## JAR-22: SAILPLANES AND POWERED SAILPLANES

Please find attached a copy of Amendment 1 to JAR-22, effective 1 August 2001.

**JAR-22, Amendment 6, 1 August 2001**

**FIGURE 1 MANOEUVRING ENVELOPE**

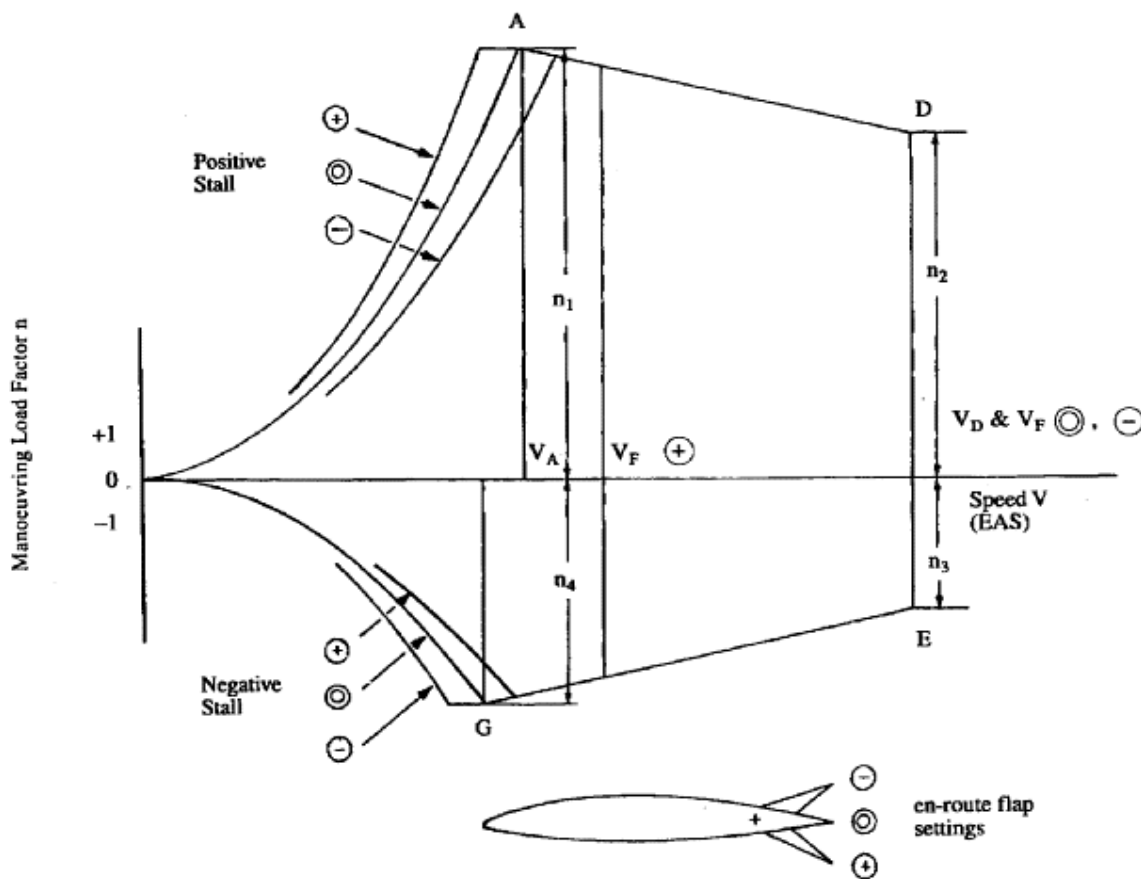
- (a) The introduction of NPA 22C–6, which:–
- (i) corrects the signs in the 'Load Factor Increment' column in the table of Category A – Additional Cases on page C–8; and
  - (ii) indicates manoeuvring load factors  $n_1$  to  $n_4$  in Figure 1, Manoeuvring Envelope, referred to in paragraph JAR 22.333(b).

**FIGURE 1 EXAMPLE OF AIR SPEED INDICATOR MARKINGS**

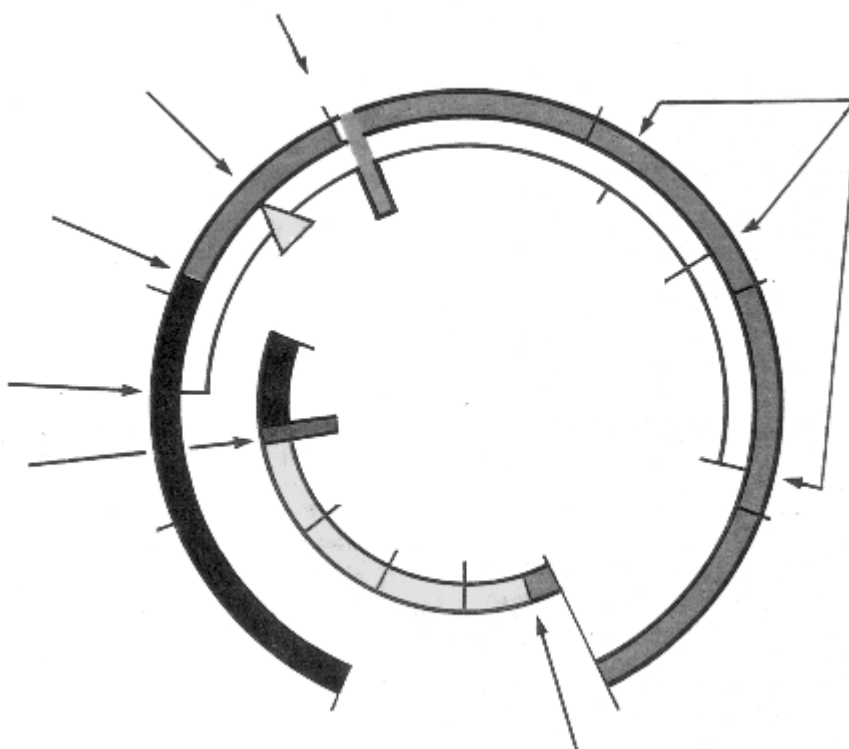
Editorial amendment to the caption of Figure 1 to clarify that the Figure is an example of airspeed indicator markings.
